**OCCUPATIONAL SAFETY
AND HEALTH STANDARDS BOARD**

**NOTICE OF PROPOSED MODIFICATIONS TO
CALIFORNIA CODE OF REGULATIONS**

Cranes and Other Hoisting Equipment With Regard to Manufacture Dates:
and the Use of Load Indicating and Load Moment Devices

Fig. 15

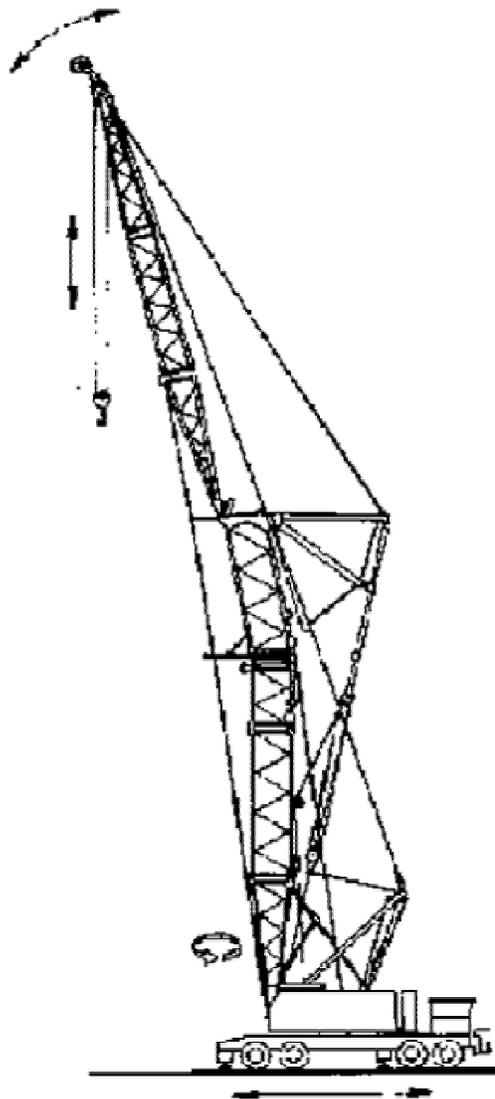
MOBILE ~~TOWER~~ CRANE
WITH TOWER ATTACHMENT

Mr. Closson pointed out regulations in Article 96, Tower Cranes that may not be applicable or may be in conflict with the design of mobile tower cranes. Section 4965(d) in part requires cranes to be equipped with a device that will effectively prevent overloading beyond the certified agent's recommendations. Mr. Closson notes the only diagram of a "mobile tower crane" in the safety orders is depicted in Figure 15. He believes the figure depicted in Figure 15 is not a mobile tower crane but rather a boom-type mobile crane covered by Article 93 of the crane orders. The type of crane depicted in Figure 15, could cause conflicting requirements for overload devices.

Amend Section 4885, Figure 15 to read as follows:

Board staff concurs that the diagram depicted in Section 4885, Figure 15 is a mobile crane with a boom attachment and is not an adequate example of a mobile tower crane that would be subject to Article 96 regulations. Board staff is proposing modifications to rename Figure 15 to read "Mobile Crane With Tower Attachment."
